Re: 2010300074 – Winnebago County
Southeast Rockford Groundwater Contamination Site
Explanation of Significant Differences Source Area 7
Superfund/Technical Reports

Explanation of Significant Differences

Southeast Rockford Groundwater Contamination Site
Rockford, Illinois
Source Area 7 Hot Spot Soil Removal

Figure 2
Proposed Excavation
Source Area 7

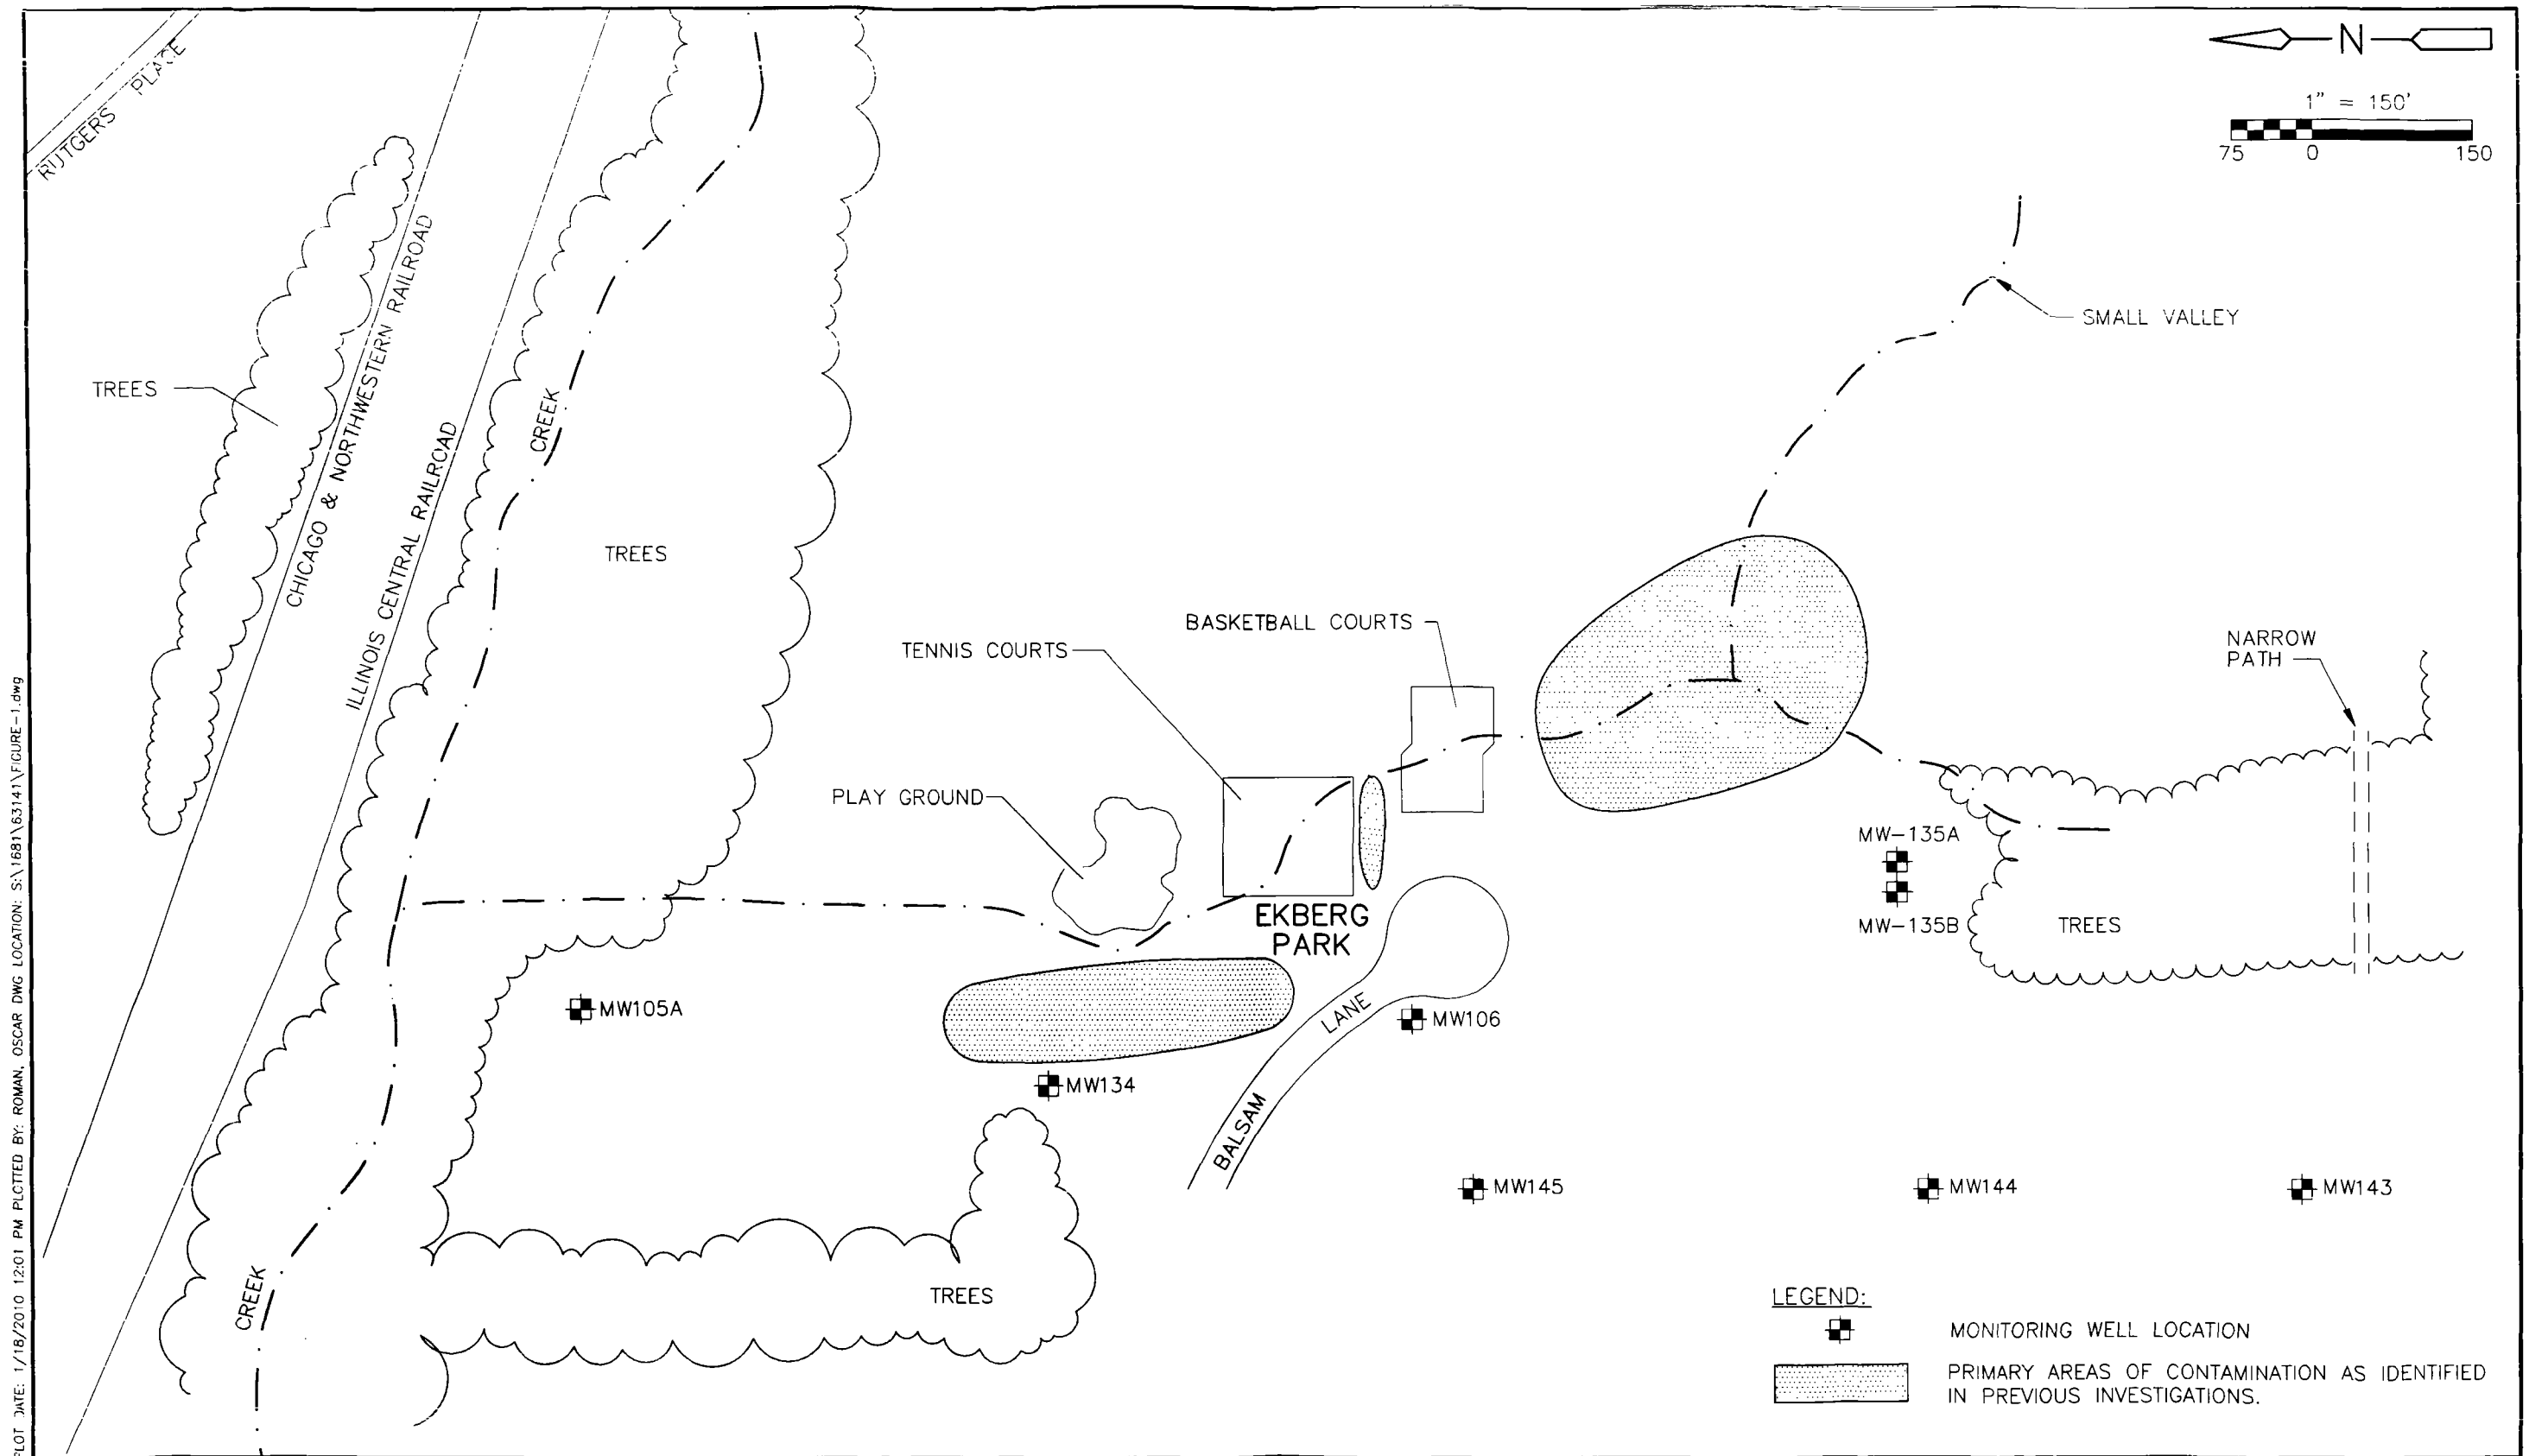
Upon completion of the Pilot Testing conducted in 2007 Illinois EPA found contaminated soil much shallower than previously detected in earlier investigations in a hot spot area just west of the playground equipment in Ekberg Park. By augmenting the selected remedial actions with limited excavation in this hot spot, the overall time required for both soil and leachate remediation may be reduced significantly. Through excavation and off-site disposal of these fine grained source materials, overall groundwater quality may be restored more quickly allowing more timely compliance with State of Illinois Class I Groundwater Standards. Currently, The City of Rockford, Illinois, and Winnebago County draw 100% of their water supply from groundwater through private, industrial and municipal supply wells. Therefore, any elimination of groundwater contamination source materials will ultimately assist in reestablishment of the groundwater to Class I groundwater standards.

The Remedial Design (RD) for Area 7 will require modification to both include the excavation component and streamlining of the SVE/AS system design. The RD is currently at the 30% phase so these changes will be easily implemented. The design for the excavation will include how the proposed excavation and off-site disposal/treatment would be conducted as well as the remedy completion sampling, testing, backfilling and capping requirements. The design modification will also address site security and safety for the excavation work.

The modifications to the SVE/AS system will include downsizing or focusing the system on those areas within Source Area 7 where the technology will be more effective. Additionally the catalytic oxidation component for the vapors will be removed or included as an option only if determined necessary at a later date.
